**Re: Initial Submission Review – Prologis Park 70 Building 19 – Contextual Site Plan and Plat**  
Application Number: **DA-1391-10**  
Case Numbers: **2019-6027-00, 2019-3030-00**

## *Initial Submission Review*

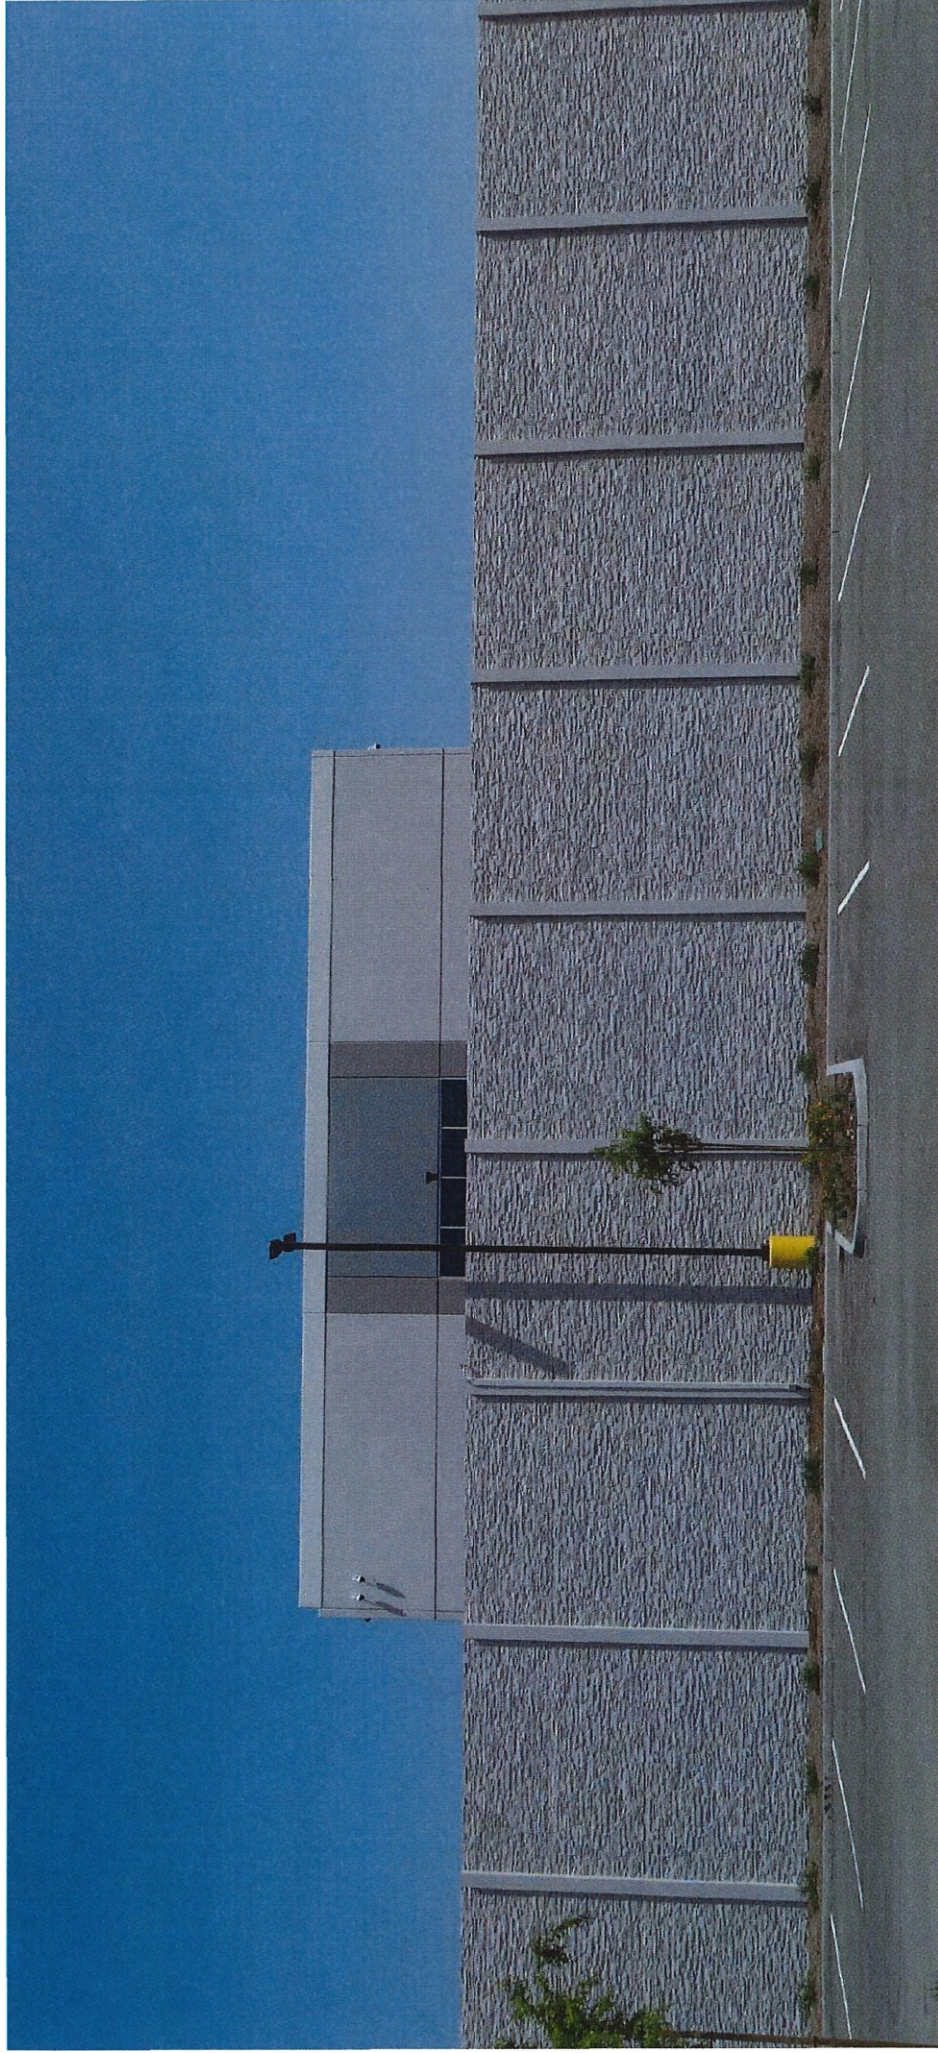
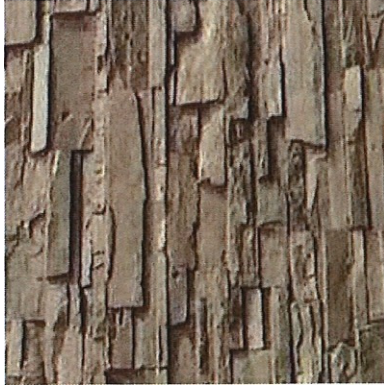
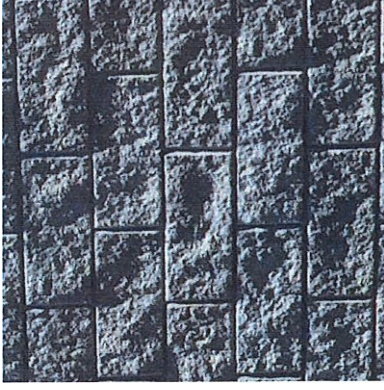
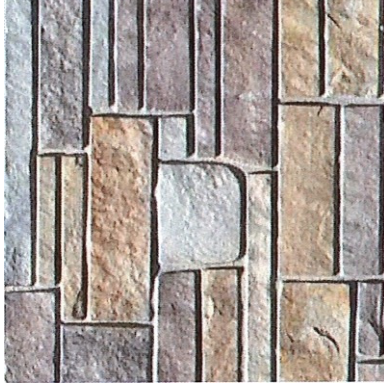
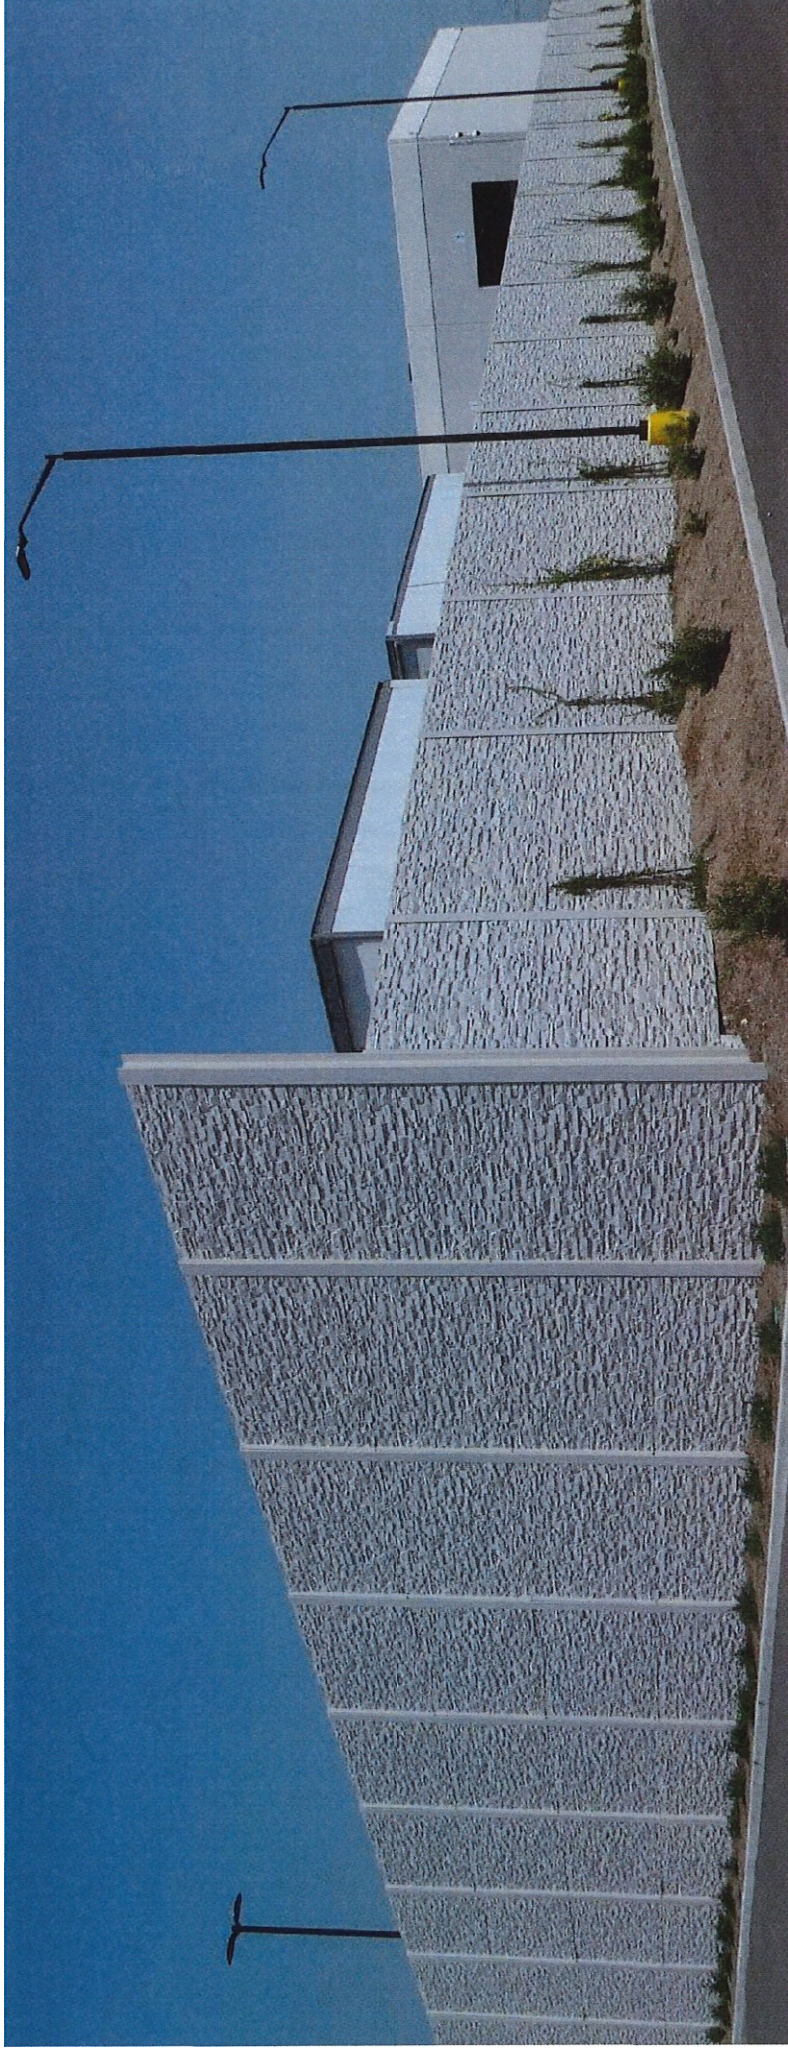
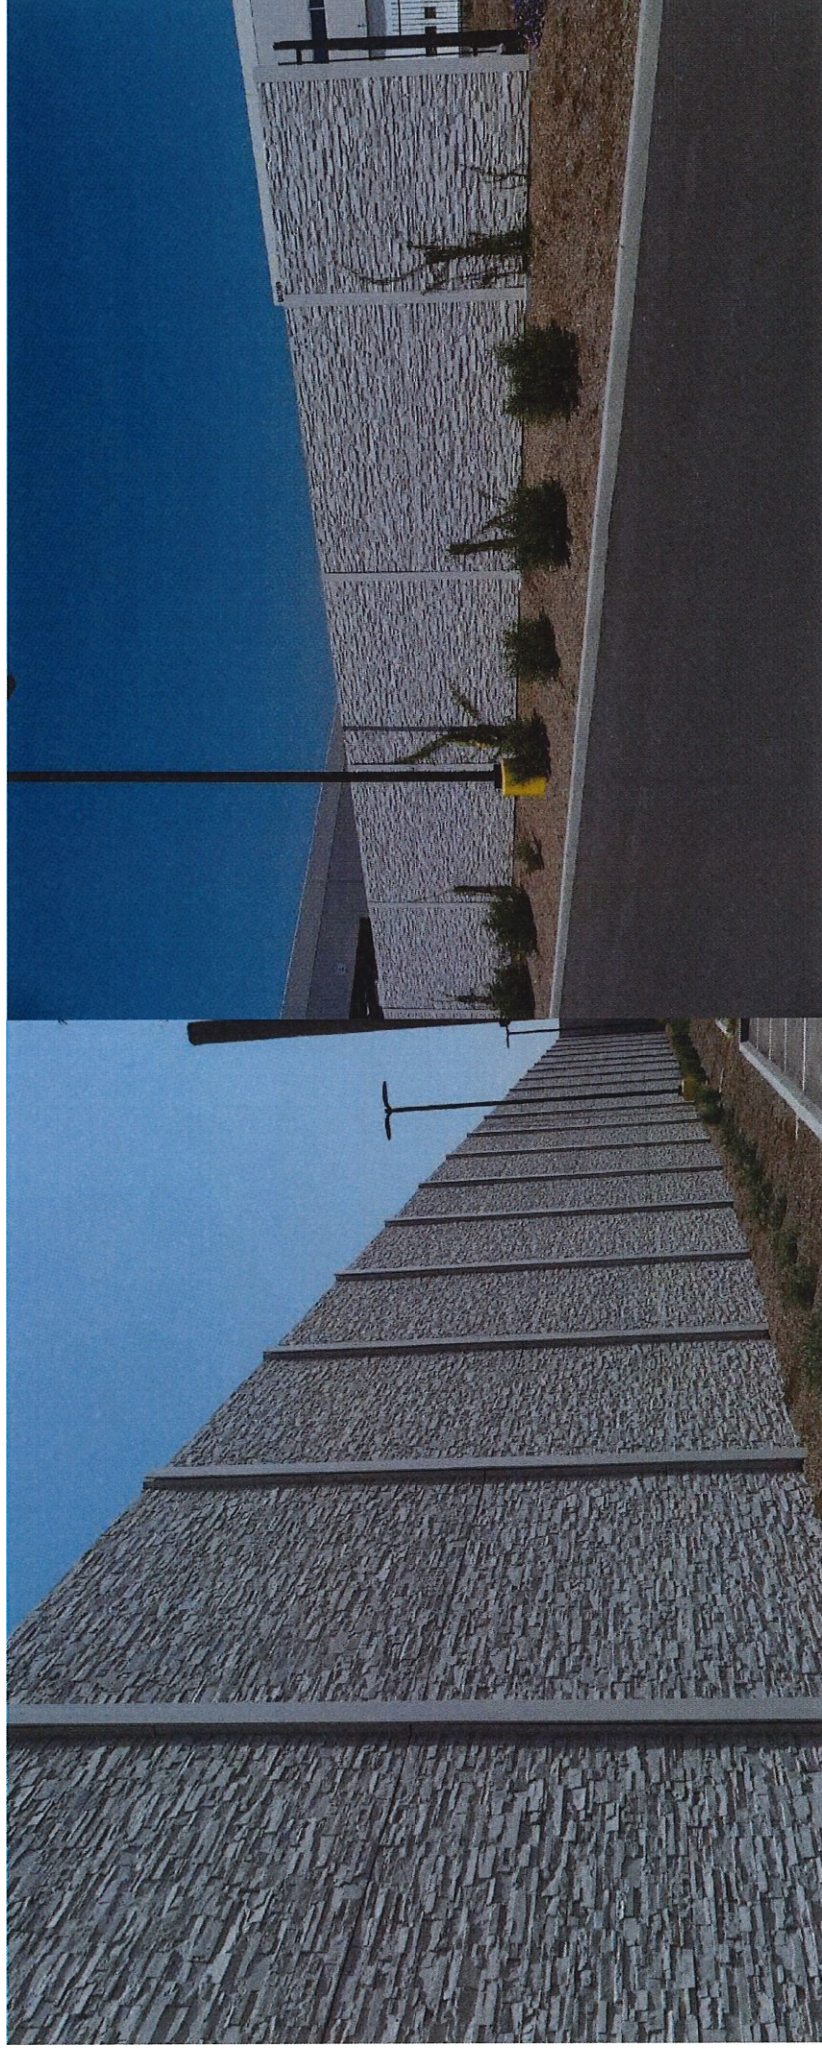
Since 1-70 is an important view corridor (and because Prologis Park 70 and the Majestic Commercenter are often mistaken as the same industrial park by the general public), we are requesting that the Applicant install opaque fencing around the outdoor storage yard. Specifically, we are requesting the fencing/screening be a "precast concrete" material in order to provide higher quality aesthetics and blend into the adjacent concrete buildings better. See Exhibit A attached for reference. This is the same fencing material that is generally required in the Majestic Commercenter; thus, we are not requesting anything that would not be required of every tenant in our business park. Additionally, we are requesting that berming and enhanced landscaping be provided around the outside storage yard, as it fronts 1-70. I note that there is a rendering of enhanced landscaping around the Building on Sheet 17 of the CSP, however, there does not seem to be any around the outside storage yard itself. In our opinion, screening (with concrete fencing, berming and enhanced landscaping) is more important for outside storage yards than the buildings (although, we expect the buildings to include landscaping as well).

Response: Screening will be provided with landscaping and berms/grading. The strategy of berms and landscaping was discussed at the pre-app meeting. The attendees at the meeting, including representatives from Prologis and the City, were amenable to the concept provided the stored products and docks are screened. Sight line studies illustrating the successful screening using berms and landscaping have been provided to the City showing views from neighboring ROW's.
